Access Compliance Report Public Rights-of-Way (Curb Ramps)

Main Street: AUGUSTA_DR		Cross Street: DALE_ST		Location:	NW
ADA ID: RPAT211130102042	Ramp Type: Type 4 - Parallel	Initial Pass/Fail: Fail	Overall Compliance: No	Severity Score:	2
Codes/Mitigation Info/Possible Solution			Field Measurements/Component Compliance

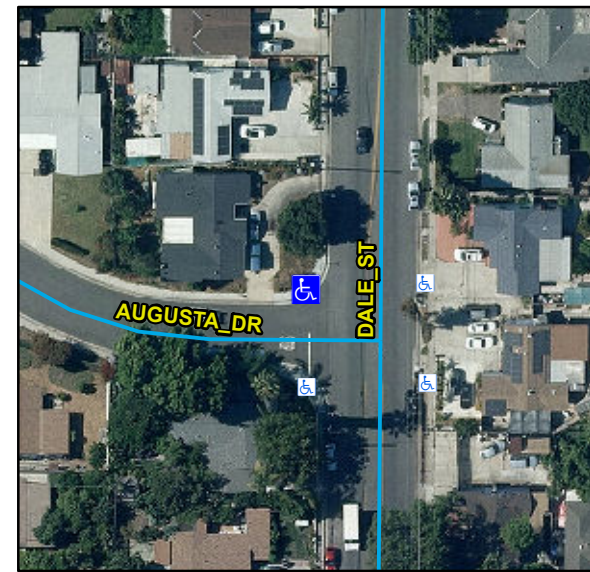
Compliance	Description	Data	Compliance	Description	Data
N/A	Ramp Length LT (in)	95	N/A	Ramp Length RT (in)	95
Yes	Ramp Width LT (in)	75	Yes	Ramp Width RT (in)	73
Yes	Ramp Run Slope LT (%)	6.8	Yes	Ramp Run Slope RT (%)	6.1
No	Ramp Cross Slope LT (%)	3.5	No	Ramp Cross Slope RT (%)	3.8
N/A	Landing Present	N/A	N/A	DWS Provided	N/A
N/A	Landing Length (in)	N/A	N/A	DWS Contrast	N/A
N/A	Landing Width (in)	N/A	N/A	DWS Length (in)	N/A
N/A	Landing Run Slope (%)	N/A	N/A	DWS Full Width	N/A
N/A	Landing Cross Slope (%)	N/A		DWS Offset Type	N/A
N/A	Landing Movement Obstructed?	N/A	N/A	DWS Offset Left (in)	N/A
	Landing Movement Type	N/A	N/A	DWS Offset Right (in)	N/A
N/A	Landing Shared	N/A			
N/A	Clear Space	Yes			
N/A	Clear Space To Crosswalk (in)	N/A			
N/A	Marked Crosswalk 1	No	N/A	Marked Crosswalk 2	No
	Crossing 1 Direction	S		Crossing 2 Direction	E
	Marked Crosswalk 1 Width (in)	N/A		Marked Crosswalk 2 Width (in)	N/A
N/A	Ramp Inside Crosswalk 1	N/A	N/A	Ramp Inside Crosswalk 2	N/A

Remove & Replace Curb Ramp With Two New Directional Ramps or Equivalent.
